Town of Surfside

RFQ 2022-05

Construction of Town of Surfside 96th Street Park

Addendum No. 4

A PARTITION WALL DETAIL
SCALE: 1" = 1'-0"

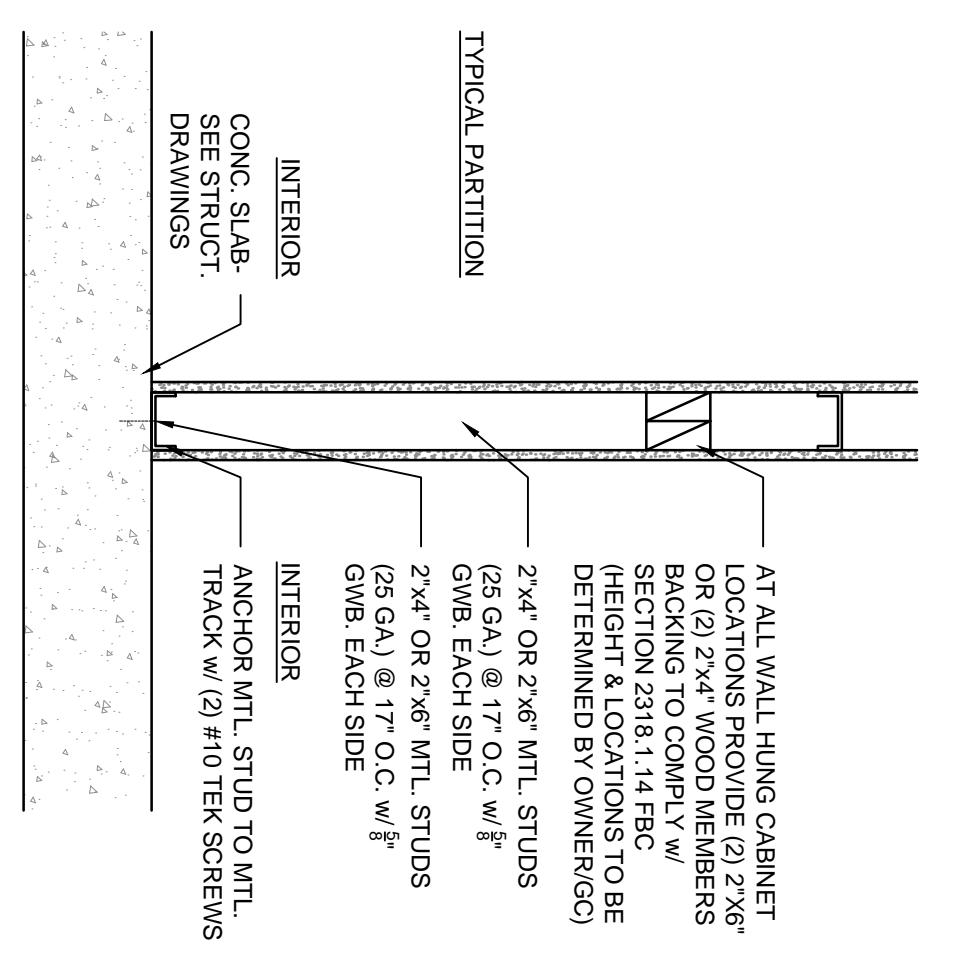
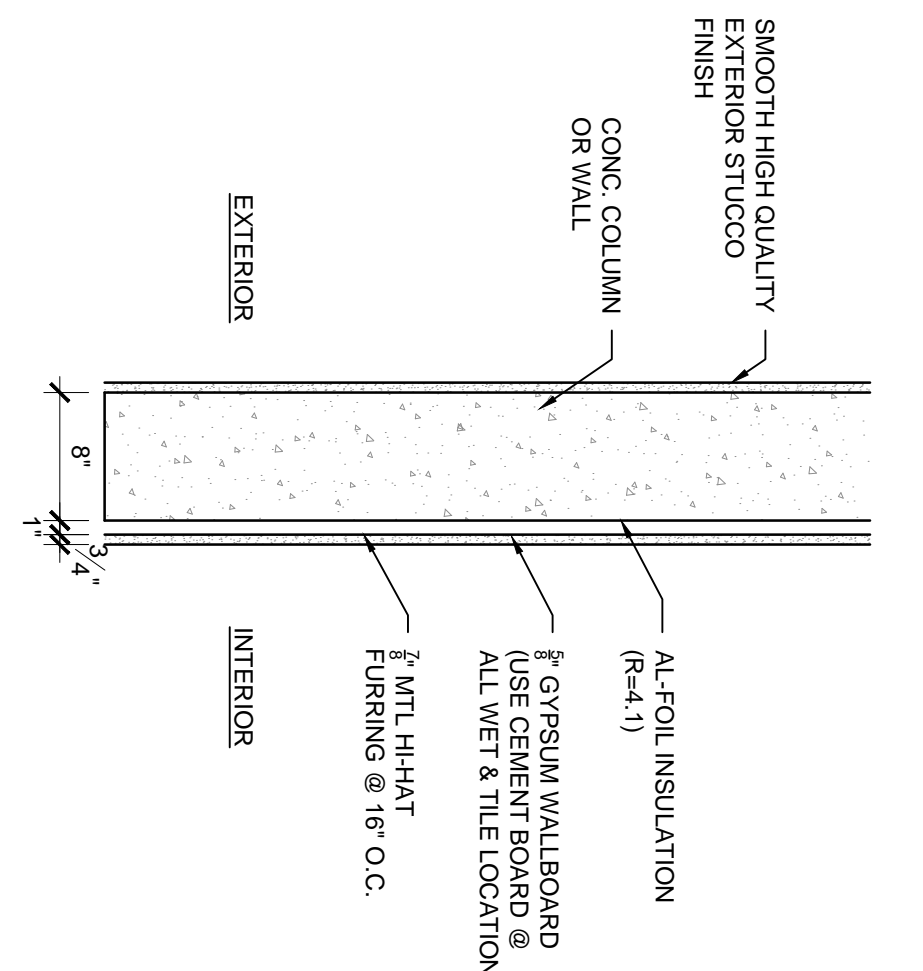
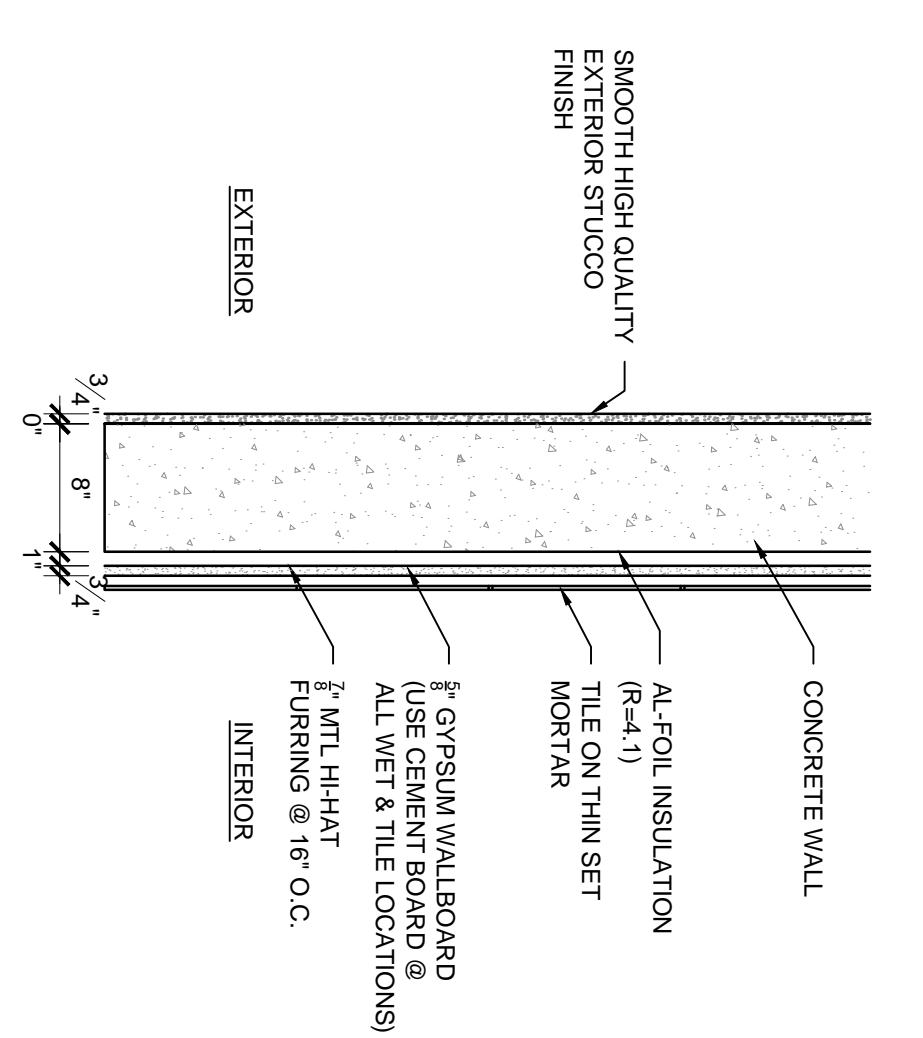
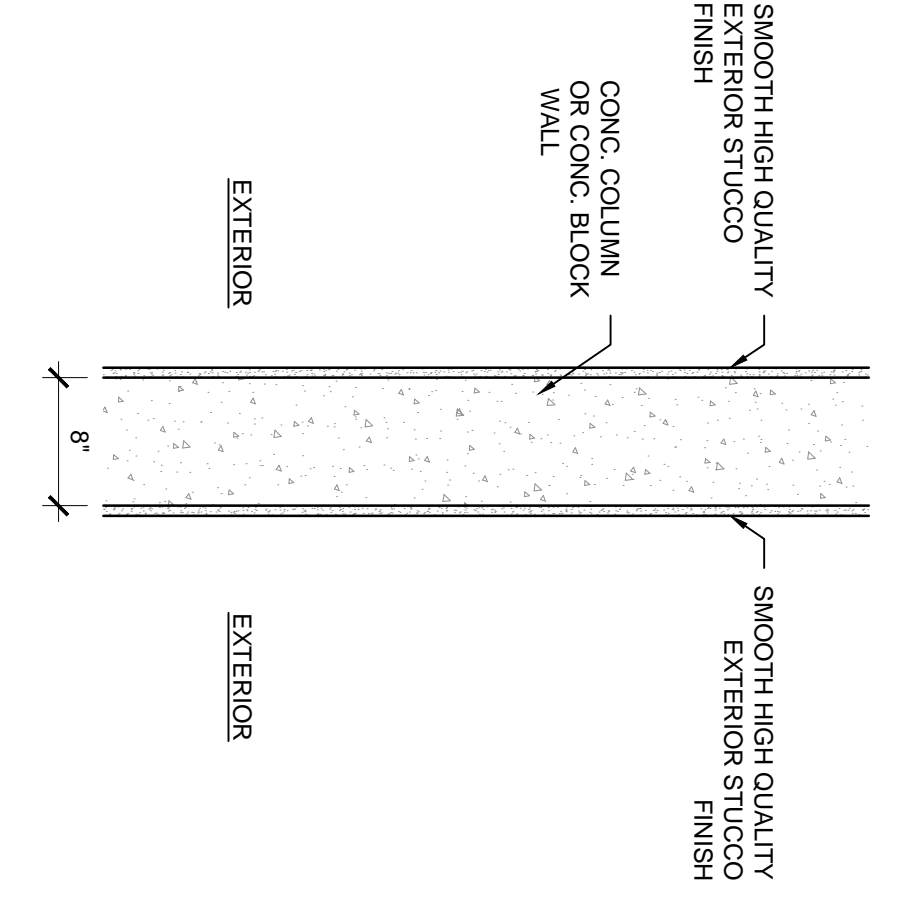
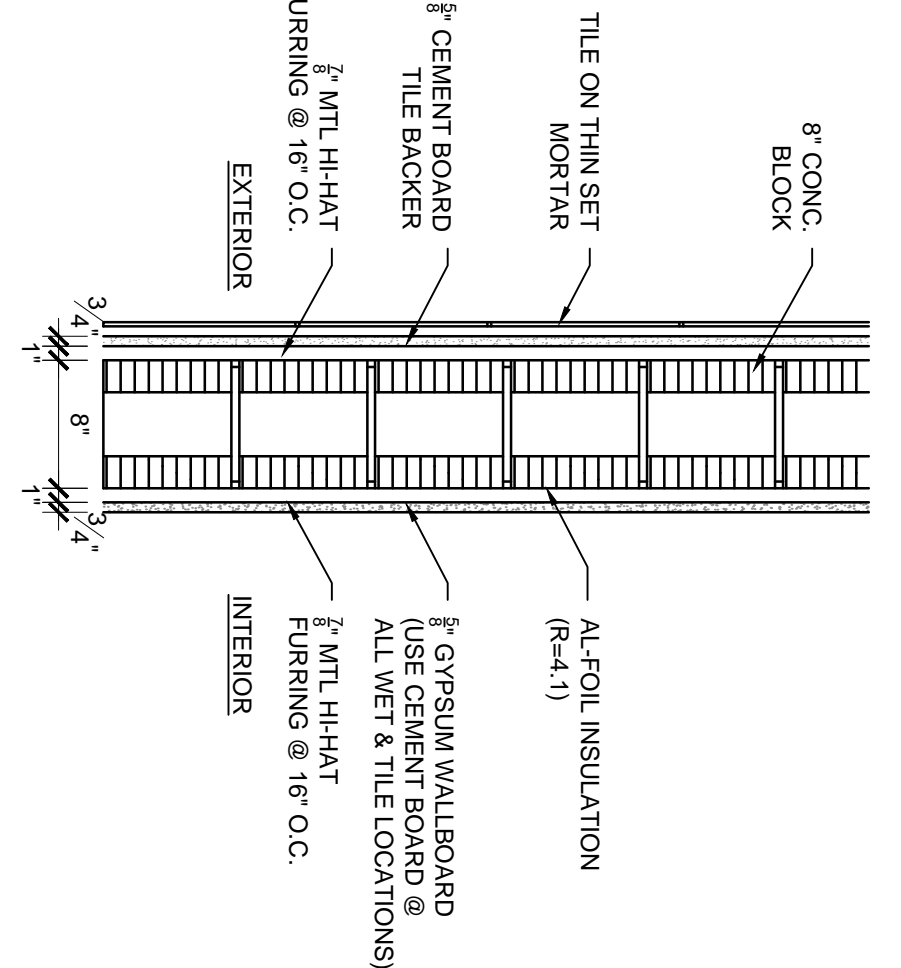
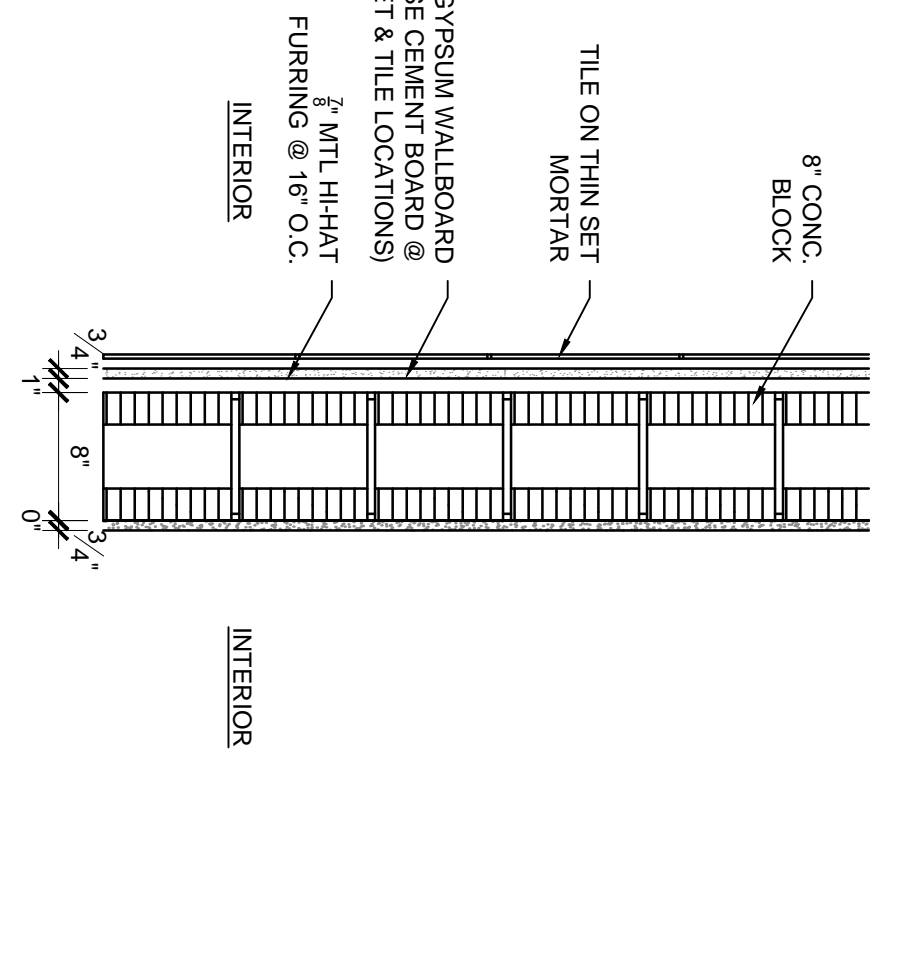
46. Architectural plans Sheet A-6.0 depicts only one Typical Wall Partition. Please provide interior wall assembly at the concrete and CMU walls.

47. Plans show ceramic tile at Men's, Women's, and Restroom Entrance. Please advise if we are installing the tiles right over the concrete/CMU walls. Refer to interior wall assembly RFI.

See A-1.0 and A-5.0 for wall details and tags.

See A-1.0 and A-5.0 for wall details and tags.

SHEET
E-301

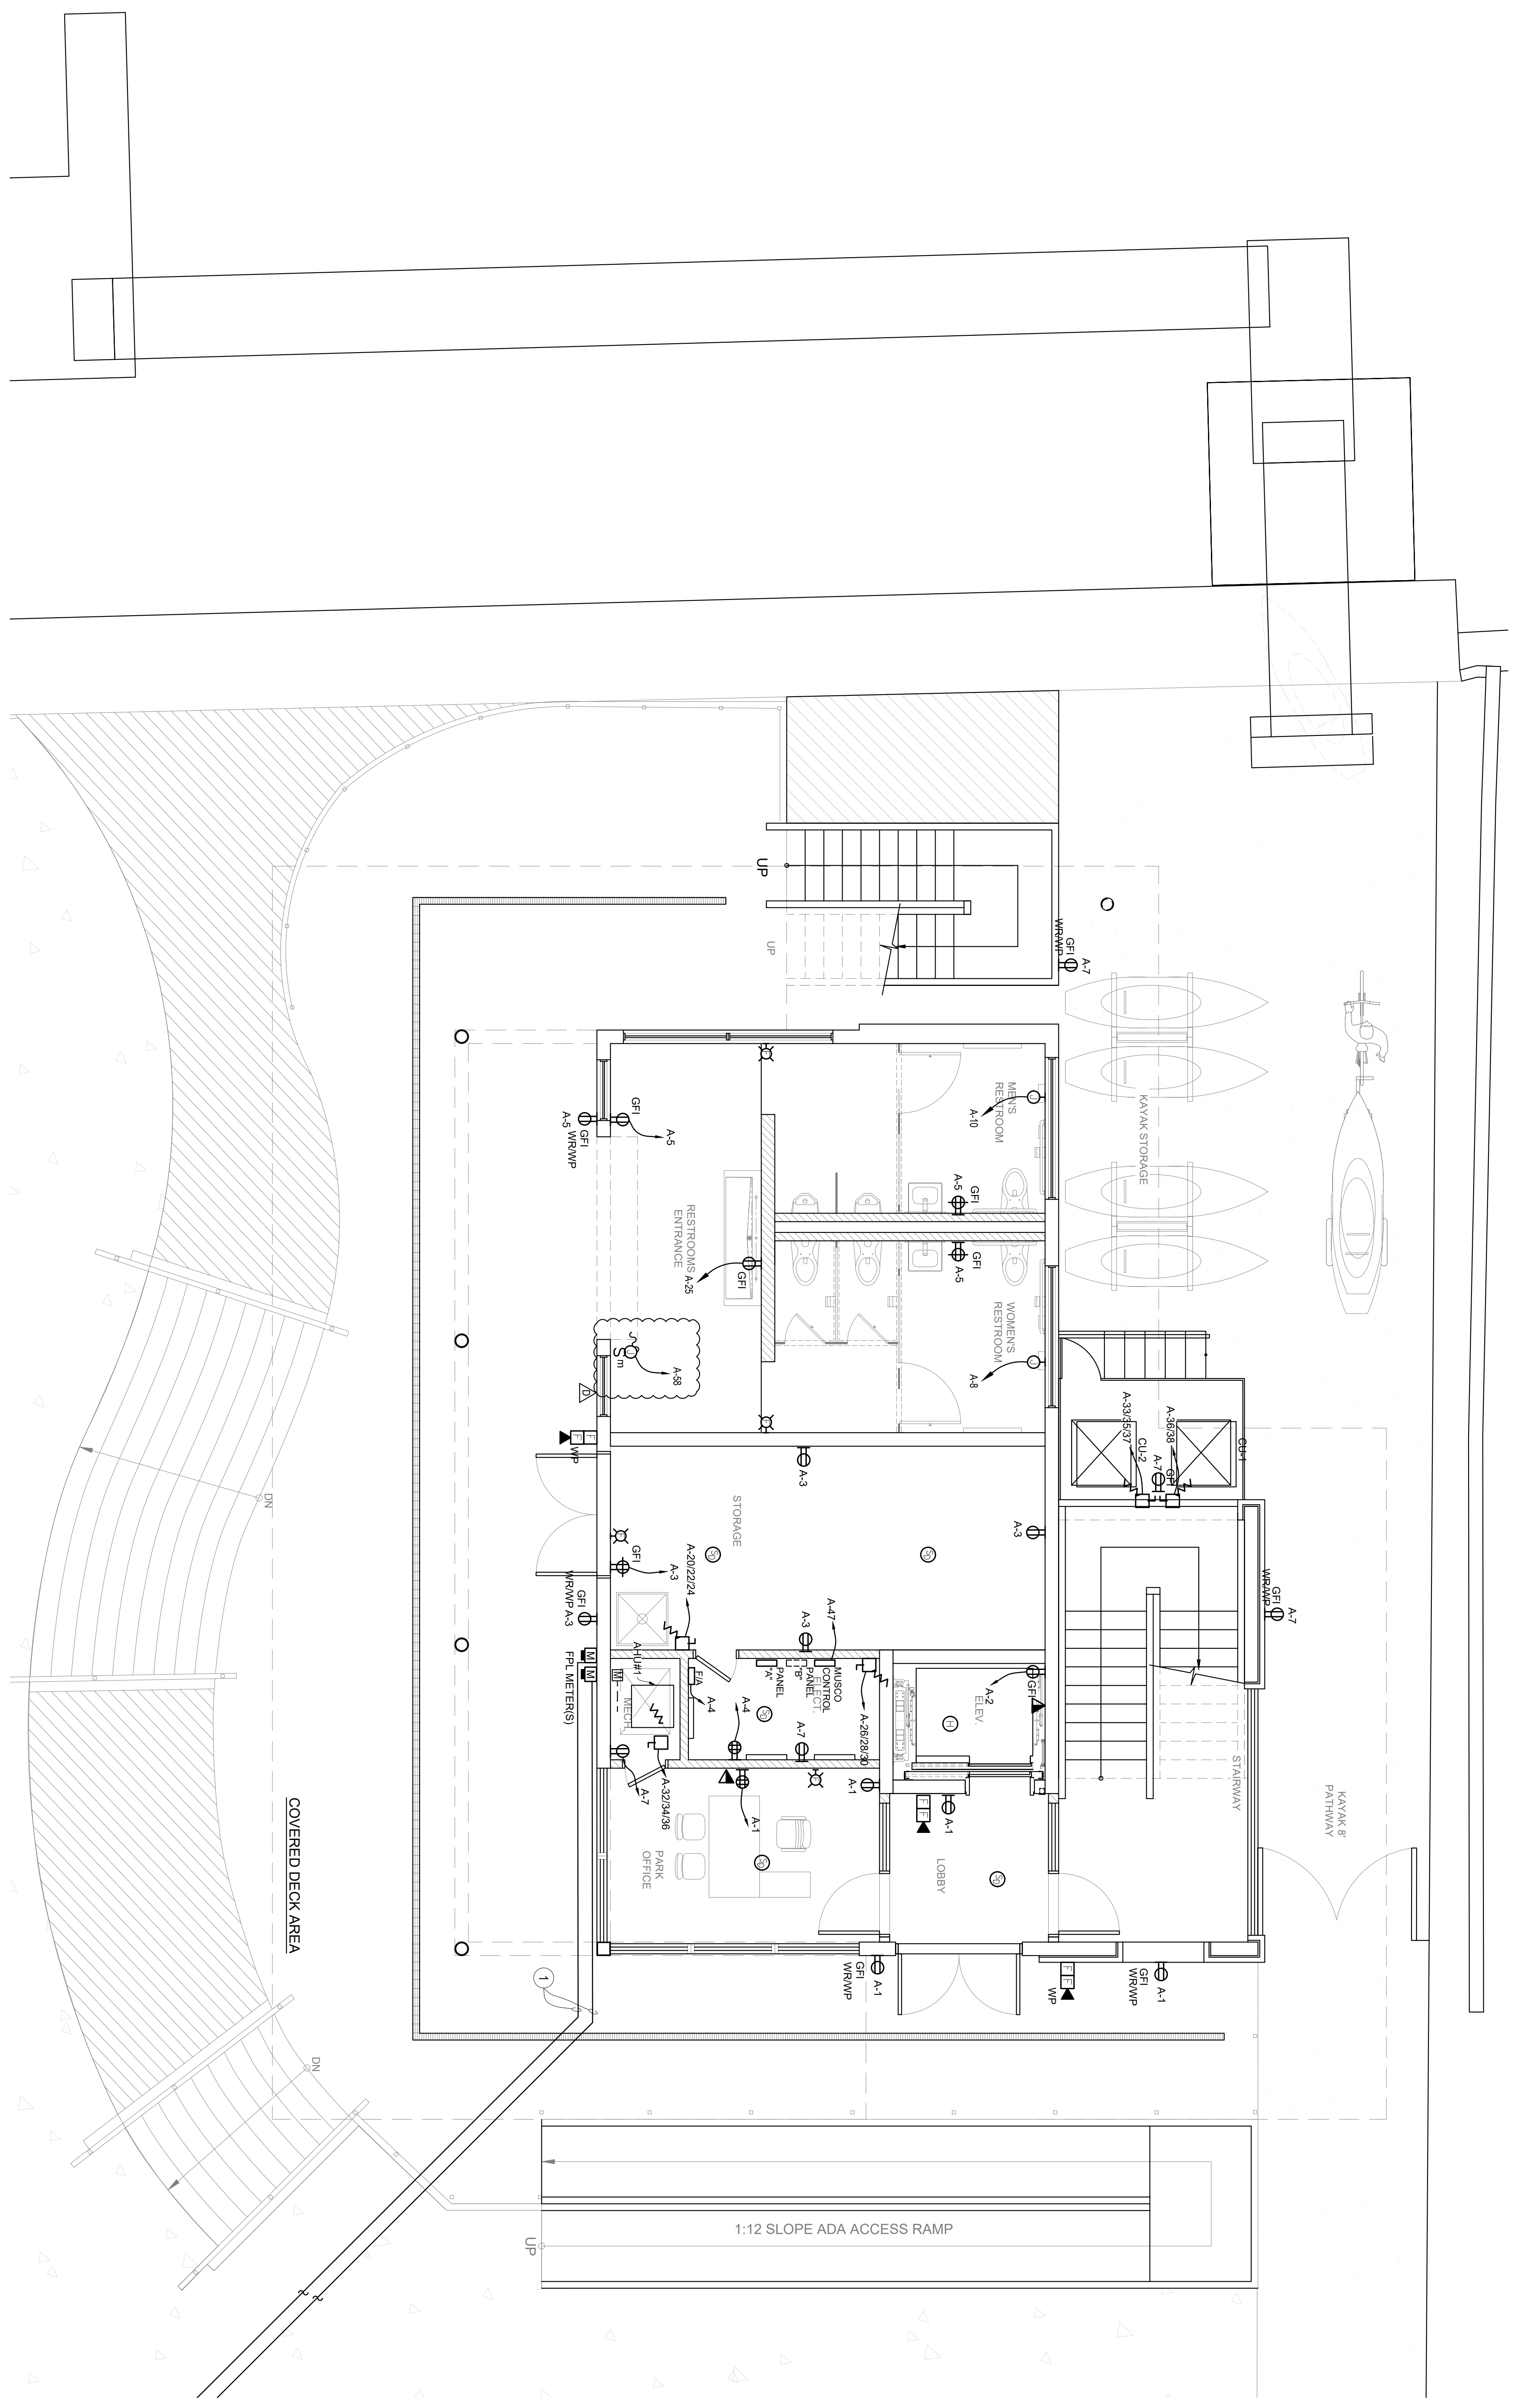
43. Restroom Entrance Elevation 2/A-4.0 notes a roll-up door. Please provide specifications for this roll-up door.

Added door tag #18 to sheet A-6.0 indicated specifications and NOA for roll-up door. Electrical circuit has been added on revised sheets E-301 and E-600.
